Issue List

05-26-25 CAVA WARWICK, RI

Issue Name : 1. RTUs On Incorrect Curbs

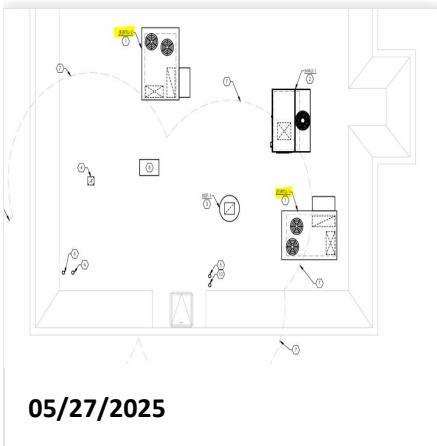
Description : The "48FCD09" unit is serving the Dining Area and the "48FCDN12" unit is serving the Kitchen. Per the mechanical plans, the larger unit is supposed to serve the Dining Area. To achieve proper cooling of the space, these units will need to be swapped.

- **05/27/2025 National TAB - Stephen Tassinaro**
 - Currently both units will be balanced to 400CFM/Ton respectively. This will not match the designs shown on the mechanical plans since there is now 4000CFM in the kitchen instead of 3400CFM. And 3400CFM in the dining room, instead of the original 4000CFM. All diffusers will be proportionally balanced.

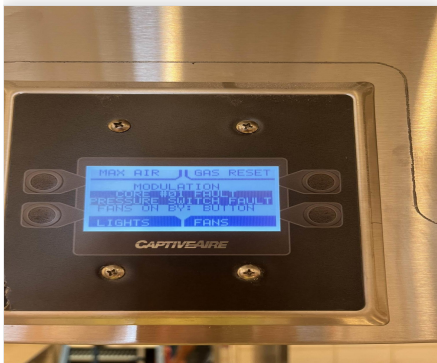
Issue Name : Flex Duct Insulation
Description : Throughout the space the flex duct insulation is not taped to the surrounding insulation. As a result the insulation is sliding down/up the duct in some areas and not providing a full seal. This may cause condensation issues. Also the damper handles were covered by the insulation. The insulation was pulled back to make the necessary adjustments.
Created By : National TAB **Assigned To :** National TAB - Will Turnbough
Status : Open
Priority : Medium **Asset Tag :**
Originated Date : 05/27/2025 - Stephen Tassinaro - National TAB
